# ENVIRONMENTAL REVIEW TEAM REPORT

## NORTH FARM SUBDIVISION MIDDLEBURY, CONNECTICUT

APRIL, 1978

FIGURE I  
SIMPLIFIED SITE PLAN MAP

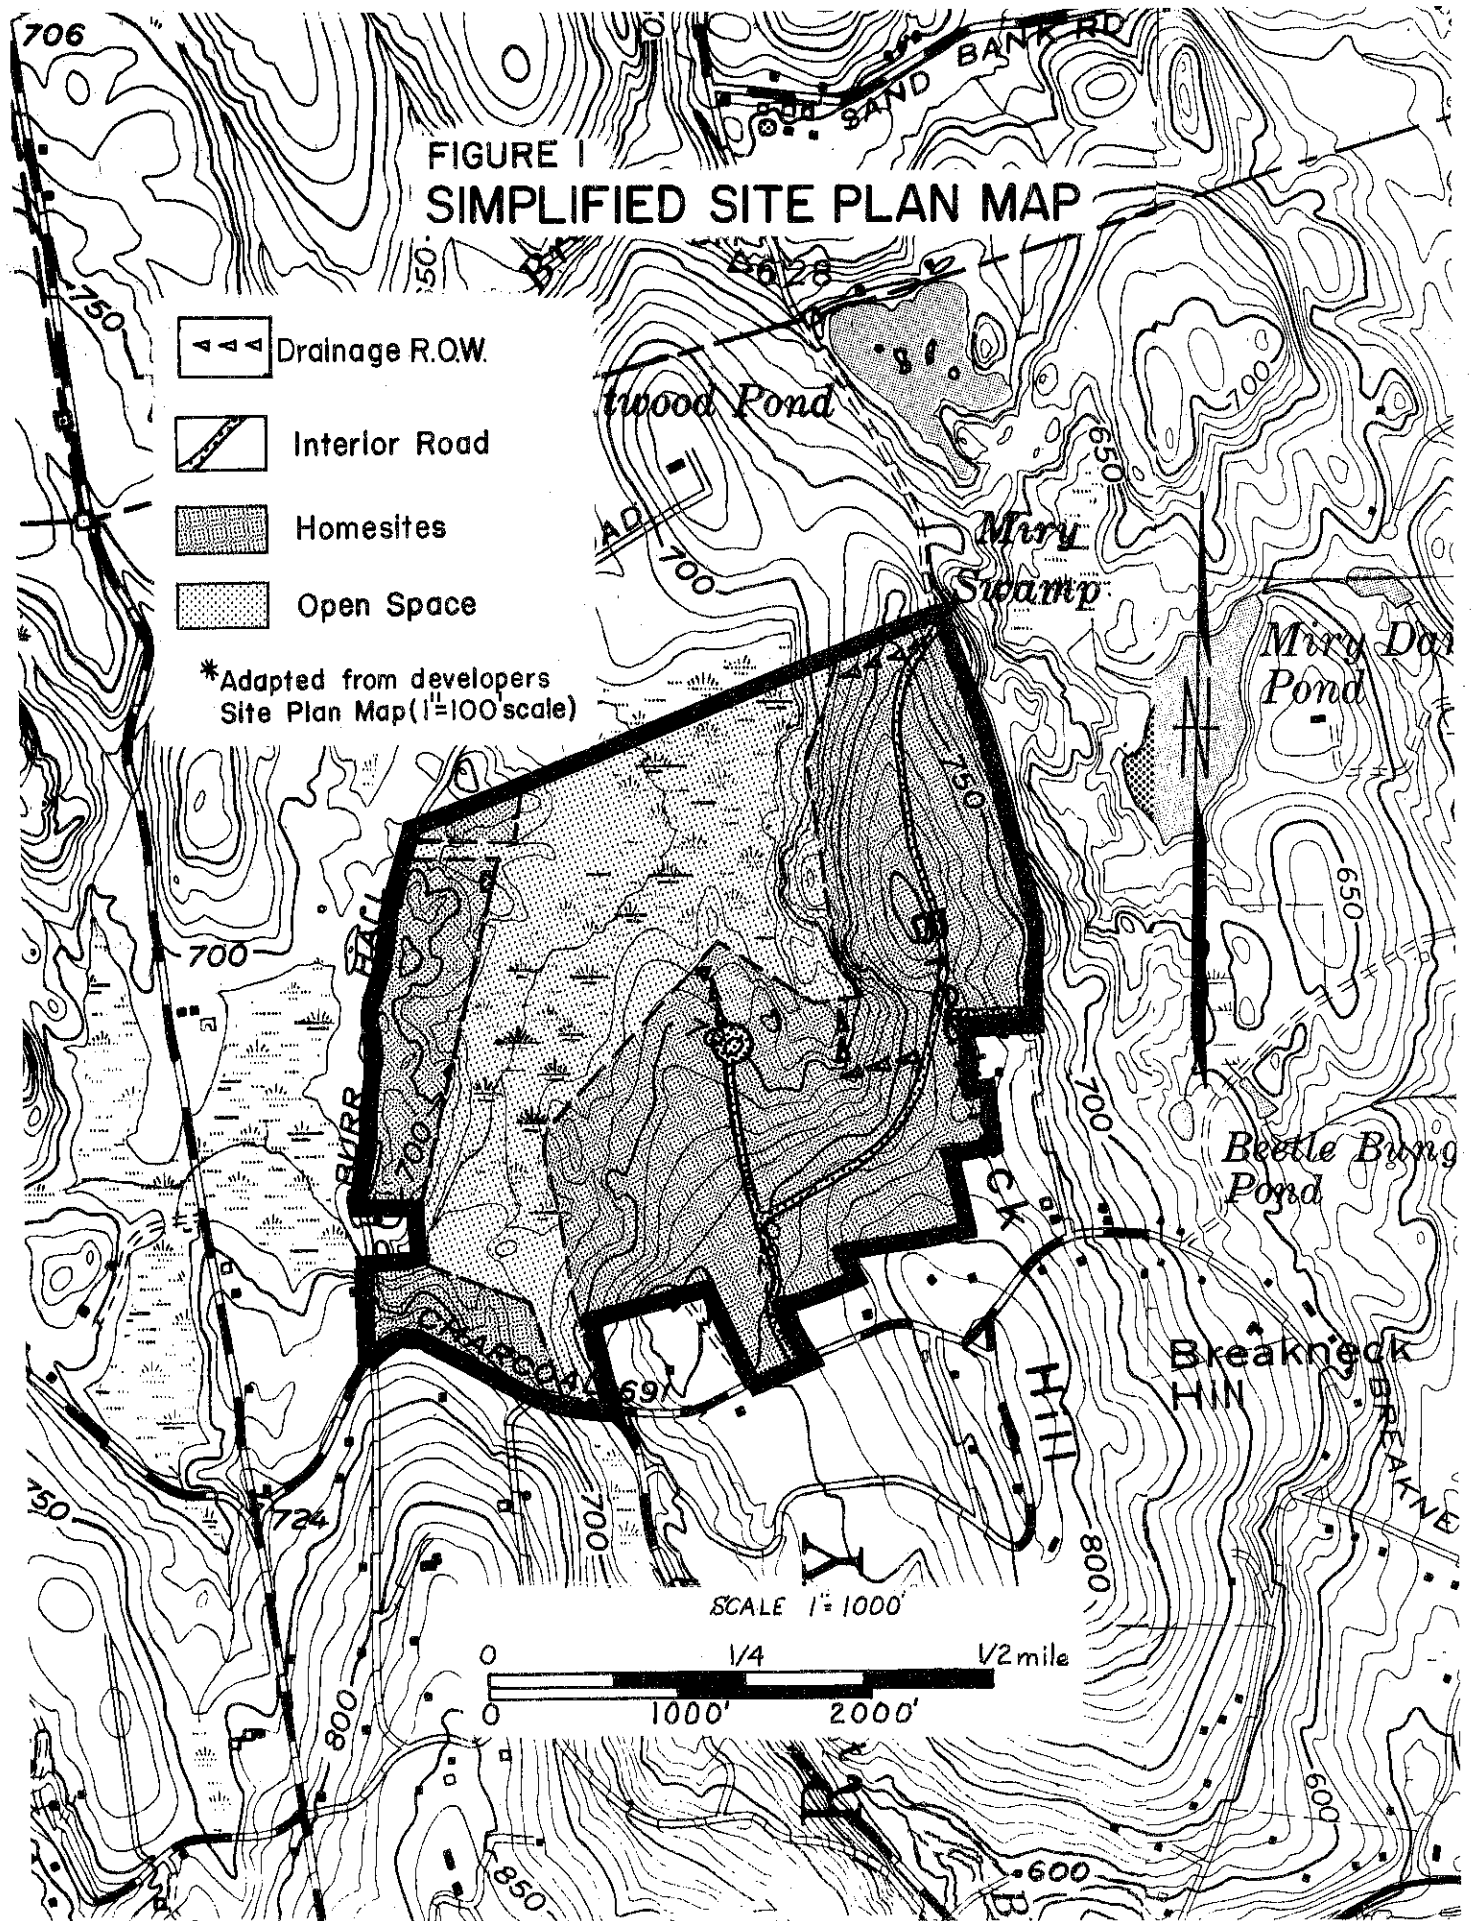
The 80 acres designated for open space consists primarily of wetlands. This wetland area is located in the west central portion of the property and bisects the proposed development. Thirteen lots are proposed to the west of this wetland area with access via Burr Hall Road and Charcoal Avenue. Fifty lots are proposed to the east of this wetland area with access via Breakneck Hill Road and Mirey Dam Road. Interior roads are proposed off Breakneck Hill Road and Mirey Dam Road. See Figure 1.

According to the developer's preliminary site plan map, the only wetland area proposed for construction is a small area where the interior road running north off Breakneck Hill Road is proposed. The concept plan also calls for the development of three storm water drains with discharge into the wetland area.

The storm drainage system proposed by the developer would affect the wetland in at least two ways. Each storm drain will introduce a rapid, concentrated flow into the lowland area. Moreover, approximately three acres of land (shown in Figure 5) would be added to the actual watershed of the brook. Drainage of the added acres normally would be to the east; however, the storm diversion channel proposed to run along one of the new roads would direct the runoff from those acres into the wetland. The impact resulting from this situation would be not so much from the amount of additional water, which is insignificant in relation to the total flow in the brook, but from its concentrated entry into the wetland. The rapid flow would decrease the lag time between the end of the storm event and peak flow volume in the brook; it might thereby enhance the potential for flooding and erosion downstream. Another major effect of the storm drainage system would be its tendency to flush road sand and salt, as well as chemical fertilizers from adjacent lawns and gardens, into the wetland. These suspended and dissolved constituents might adversely affect the biota of the swamp and, in a chain-reaction, other physical characteristics. Further, the deposition of road debris from these points of discharge would result in the creation of sediment fans over certain sections of the wetland. Measures mentioned in a later part of this report might do much to alleviate most of the aforementioned problems.

The developer's proposed storm drainage system seems reasonable. To ameliorate the damaging effects of rapid discharges from storm drains into the wetlands, each outlet pipe should be carried down beyond steep slopes to a safe outlet and also have some sort of an energy dissipator to reduce the energy of flowing water. In addition, holding basins should be constructed at the end of each basin. These basins would consist of a small reservoir with a pipe to regulate outflow. The holding basins would accumulate storm water temporarily and diminish the peak flow in the brook. Also, they would collect most of the sediment carried in the drains and would thereby prevent the formation of sediment fans. These basins would require regular cleaning and maintenance.

Good engineering needs to be exercised in the construction of the outlet pipe going down over the slope near lot 20. This area has a steep slope and is eroding at the lower end of its natural drainage. It appears that two or more manholes would be required for alignment and grade purposes. These manholes should also have catch basins to collect surface water run-off and in turn, control erosion of the drainageway.

**FIGURE 4  
SURFICIAL GEOLOGY**

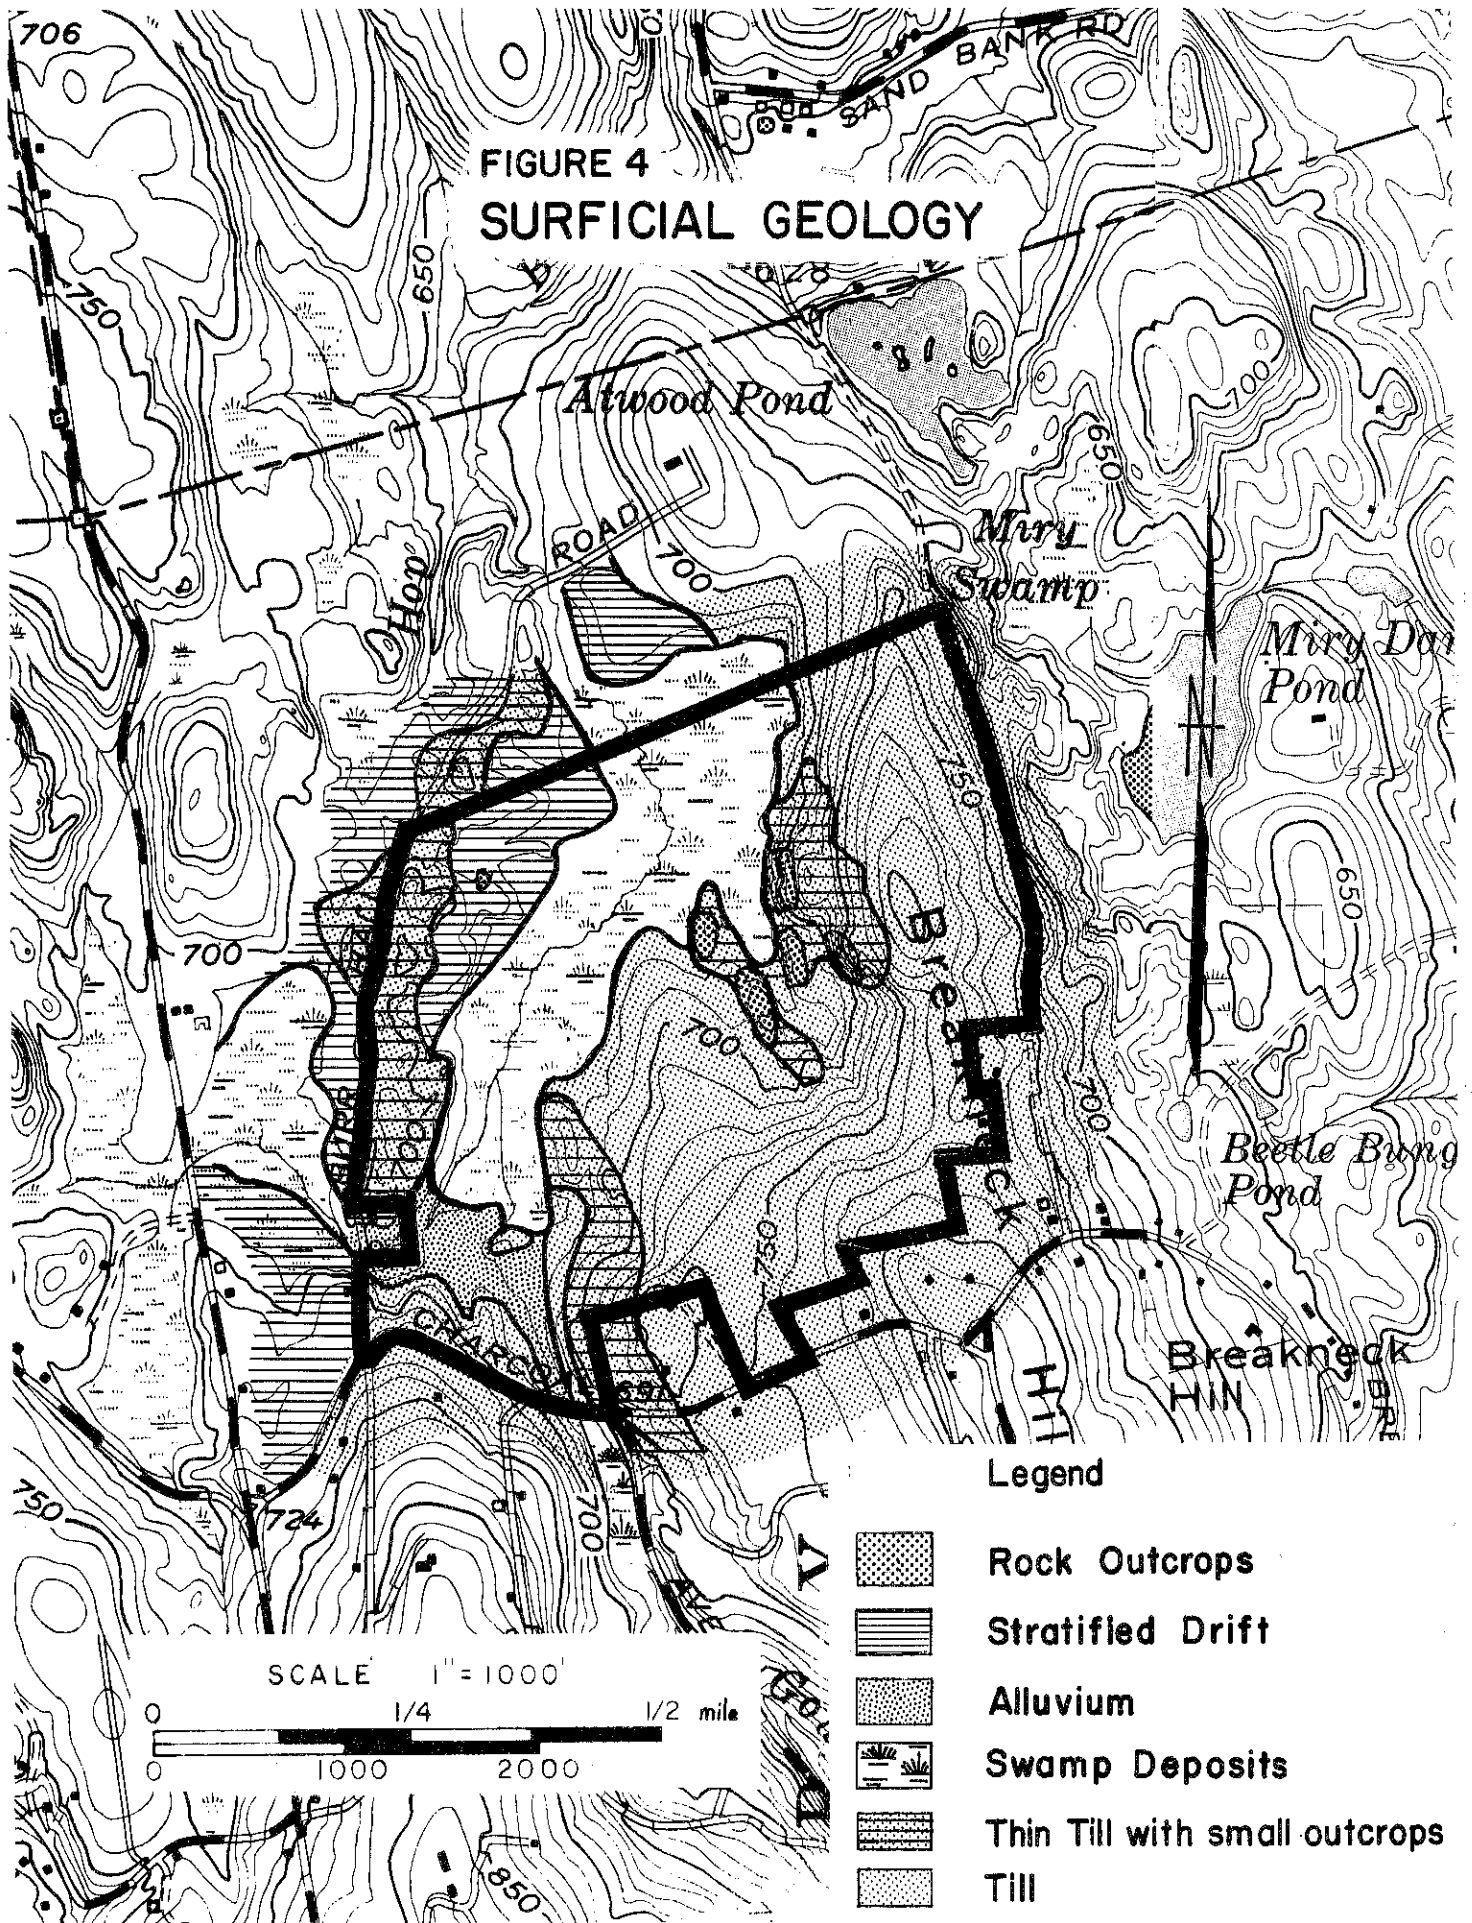
The developer reported finding a dry gravelly material in several shallow excavations on lots within the section of Breakneck Hill mapped as till. It is likely that this coarse material is actually the loose, light gray till mentioned by Pessl in GQ-896. Because the excavations were made in an area proximal to a known deposit of stratified drift, it is also possible that the gravelly material is a thin layer of stratified drift resting on or embedded within the till.

At several places within the property, bedrock is exposed or lies close to the surface. Such areas are separately designated in Figure 4.

Shallow depth to bedrock conditions might hamper the placement of septic tanks and leaching fields in lots along Burr Hall Road. Lots on Breakneck Hill generally avoid the thin till areas and will probably not be adversely affected by shallow bedrock. However, hardpan may prove a more formidable challenge on the hill. The developer reported finding both hardpan and a gravelly material in shallow excavations in the area. This is not surprising, as till commonly varies from point to point, but it does suggest the need for close inspection of the surficial materials in each lot before a location for the septic system is proposed.

FIGURE 6

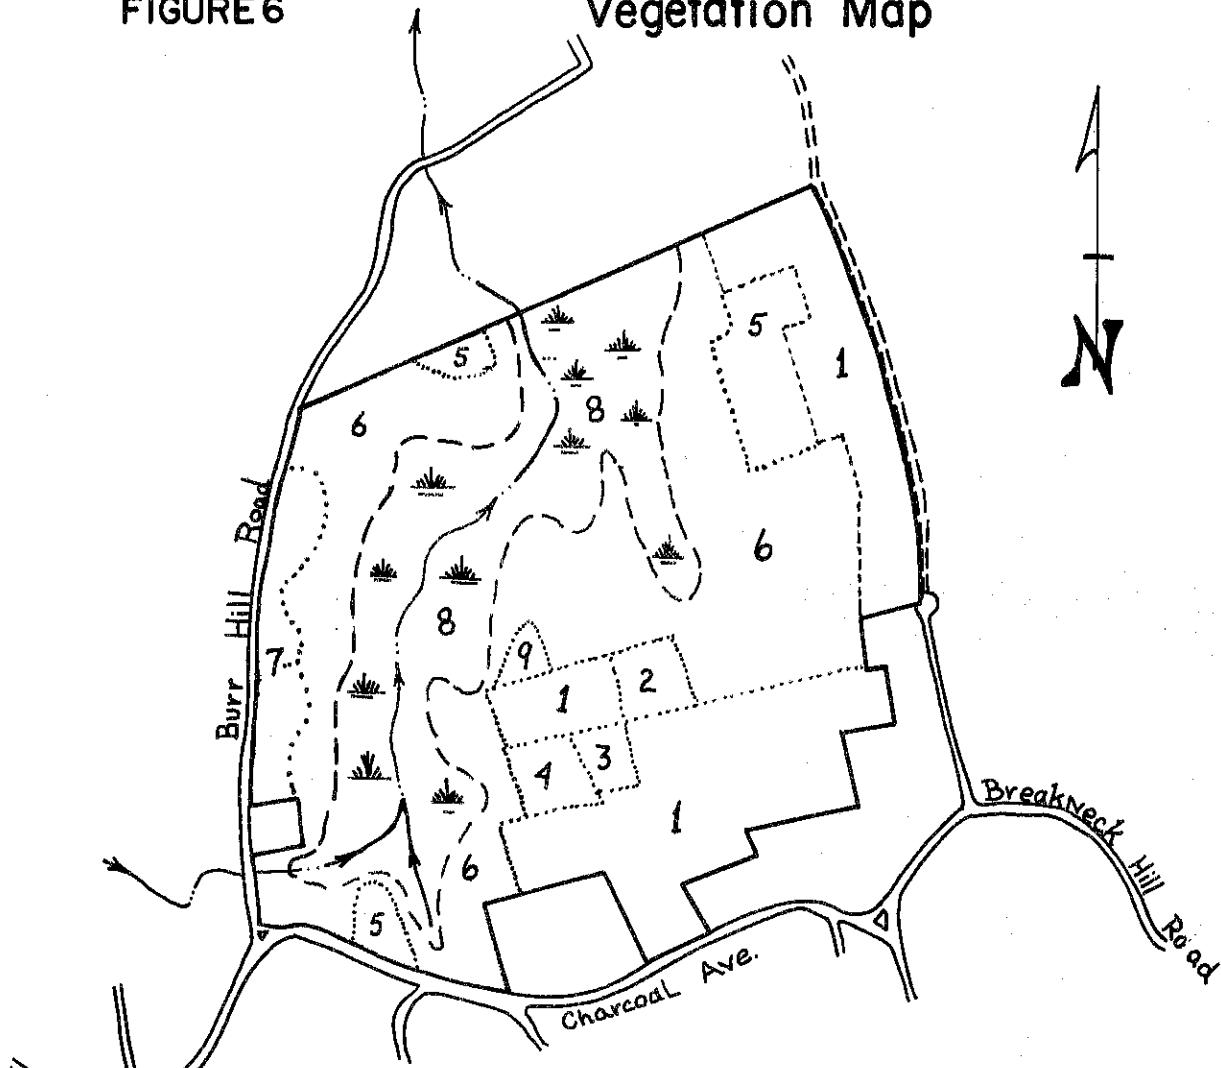
Recommendations - Where possible, hedgerows should remain intact. Dead and dying trees should be removed as they are a potential hazard. Consideration should be given to planting of lot lines and roadsides with conifers such as white pine, larch and hemlock. All interior wire fences should be removed.

Recommendations - See Stand 1 recommendations. Effort should be made during development to retain better quality saplings as potential shade trees (minimum 6 per acre).

Recommendations - Over 1/2 the volume on this area is defective and could be removed prior to development in a cordwood harvest of 7 - 10 cords/acre. Probable yield - 35 cords. Hedgerows should be left intact where possible. They will act as windbreaks and will reduce wind throw damage after development. Interior wire fencing should be removed.

Recommendations - Consideration should be given to retaining unbuildable acres in open space due to high aesthetic value of stand. Management of this area should include removal of 1/4 of the volume immediately. This will open up the crown and allow more sunlight to reach the ground, stimulating reproduction. At the same time this will stimulate growth in existing stock. A similar harvest should be scheduled 5 to 10 years later and removal of the remaining volume 10 to 15 years following that harvest. This will, in effect, rejuvenate the entire stand. As this stand is of high aesthetic value, consideration should be given to encouraging the owners of these lots to permit others to walk and hike on this land. Cooperation of these lot owners would also facilitate forest management of the area.

Recommendations - Those areas which are inaccessible to forest management and undevelopable should be retained as natural areas. There is not enough sawlog size material on the remainder of the stand to warrant a sawlog harvest, but a cordwood harvest of the poorest quality 1/3 of the volume is feasible. This would yield approximately 5 cords per acre or approximately 250 cords. At the same time this harvest would improve the overall health of the area. All hedgerows should be maintained intact where possible and any interior wire fences should be removed.

Recommendations - Removal of all dead and dying material as cordwood should yield 3 cords/acre or 27 cords. Planned development should eliminate much of the laurel undergrowth and landscaping plans here should favor softwood species such as white pine, larch and hemlock rather than hardwoods. Consideration should be given to planting along lot lines with these species.

Recommendations - This area could have high value as a wildlife area. Pruning of fruit trees would increase fruit yield as would removal of brush competition from around these trees. Development plans should attempt to preserve as much of this area as possible.
